Subject: **INFORMATION:** Review and Concurrence. Equivalent Level of Safety for Fuel Cutoff Control for the Eclipse 500 Aircraft (Ref. 14 CFR Part 23, §§ 23.777(d) and 23.781(b) Fuel Cutoff Control)(FAA Project TC3853CH-A) ; ACE-02-19

Date: MAR 15 2002

Subject: Request for an Equivalent Level of Safety Finding for 14 CFR Part 23, §§ 23.777(d) and 23.781(b) Fuel Cutoff Control for the Eclipse Model 500 (FAA Project TC3853CH-A)

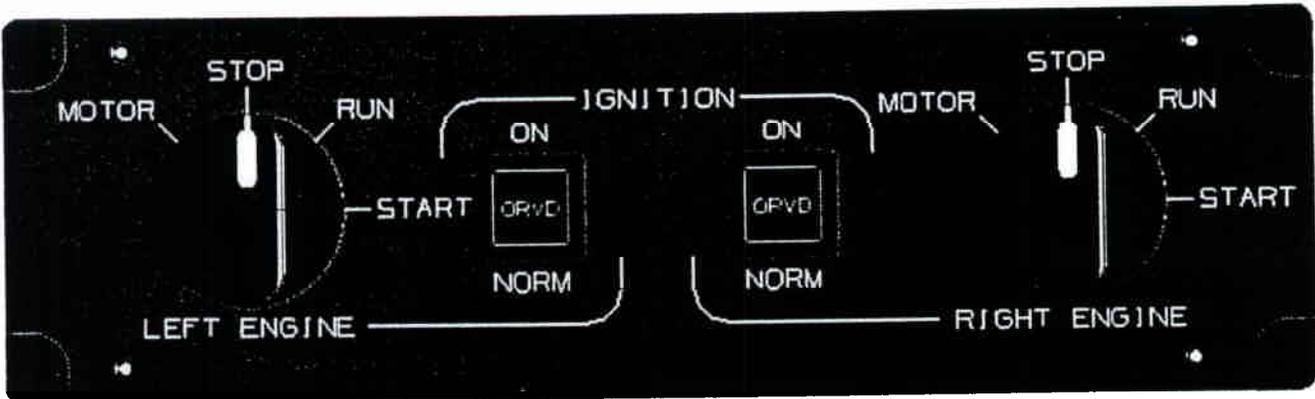
The Eclipse Model 500 fuel cutoff is on a four position, rotary knob located on the center, overhead panel (please see attached). The four positions are MOTOR/STOP/RUN/START. The MOTOR position is spring-loaded, so the pilot has to hold it in place to function or it will return to the STOP position. The START position is also spring loaded, and once the start sequence is started, the pilot releases the knob and it then goes to the RUN position. To go from RUN to STOP (fuel cutoff), the pilot must push in the knob and rotate it to STOP. This is to safe guard against inadvertent fuel cutoff.

There are two other push buttons located on the overhead panel used for ignition over-ride. Since push buttons require a different action to initiate, there cannot be inadvertent fuel cutoff with any action used for ignition over-ride. These are the only items located on the overhead panel.

As described above, the design of the Eclipse Model 500 fuel cutoff precludes inadvertent cutoff by the pilot. The design also precludes inadvertent action by the pilot of another function. Therefore, we believe the design provides a level of safety that exceeds the intent of the requirements for fuel cutoff contained in §§ 23.777(d) and 23.781(b). We request the FAA provide concurrence with this finding.

Key features that provide an ELOS: As described above, the design of the Eclipse Model 500 fuel cutoff precludes inadvertent cutoff by the pilot. The design also precludes inadvertent action by the pilot of another function. Therefore, the CHI-ACO position is that the design provides a level of safety that exceeds the intent of the requirements for fuel cutoff contained in §§ 23.777(d) and 23.781(b)

Recommendation: Approve request for an ELOS to 14CFR Part 23, §§ 23.777(d) and 23.781(b) Fuel Cutoff Control, based on no other equipment placed on the overhead and the System Safety Assessment per § 23.1309 is acceptable.
